PRR Comments

PRR Number	830	PRR Title	Reactive Power Capability Requirement
------------	-----	-----------	---------------------------------------

Date	11/10/2009
------	------------

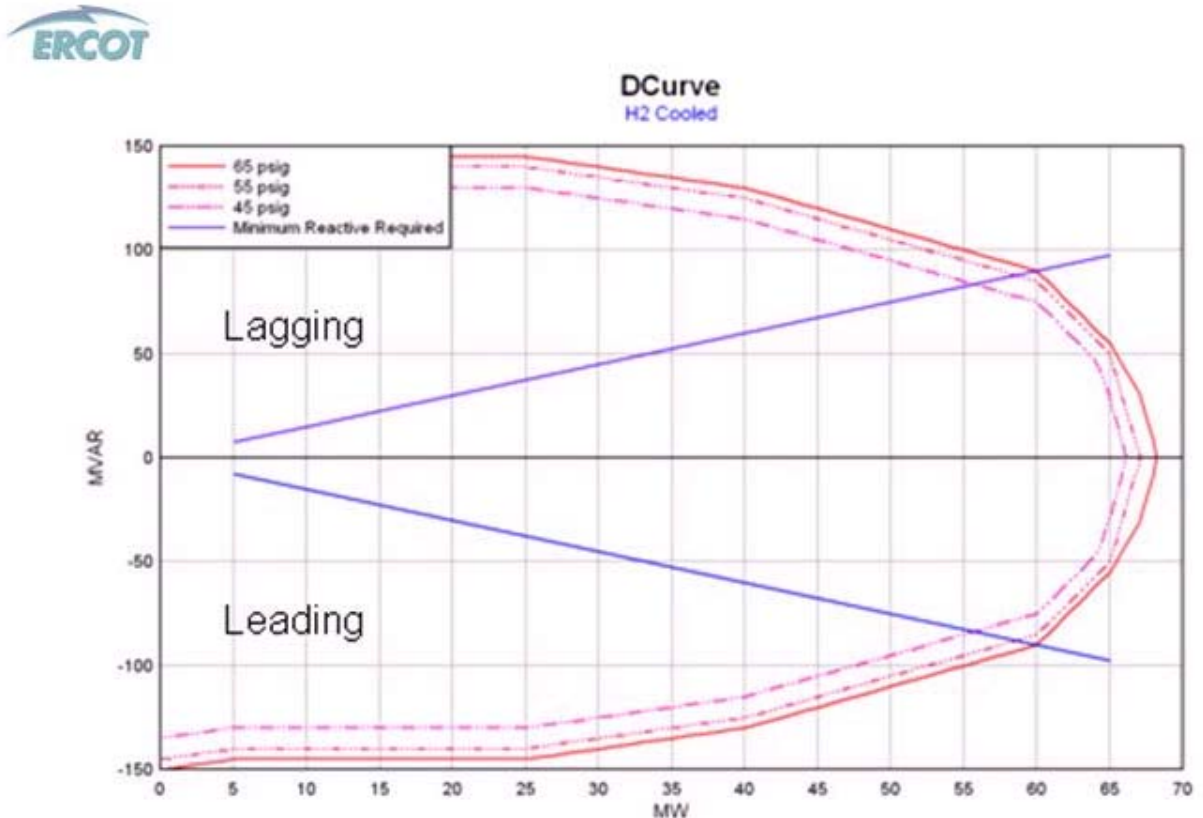
Prior to PRR 830, the “cone” reactive requirement was clearly defined in the Protocols and related ERCOT documents and has been accepted by ERCOT as detailed in the individual generator registrations (RARF).

b) The ERCOT Resource Registration Guide as recently as June 2009 illustrated the “cone” requirement in section 7.4. As noted in the diagram from page # 30 below the purple line illustrates the “Minimum Reactive Required” as the “cone”
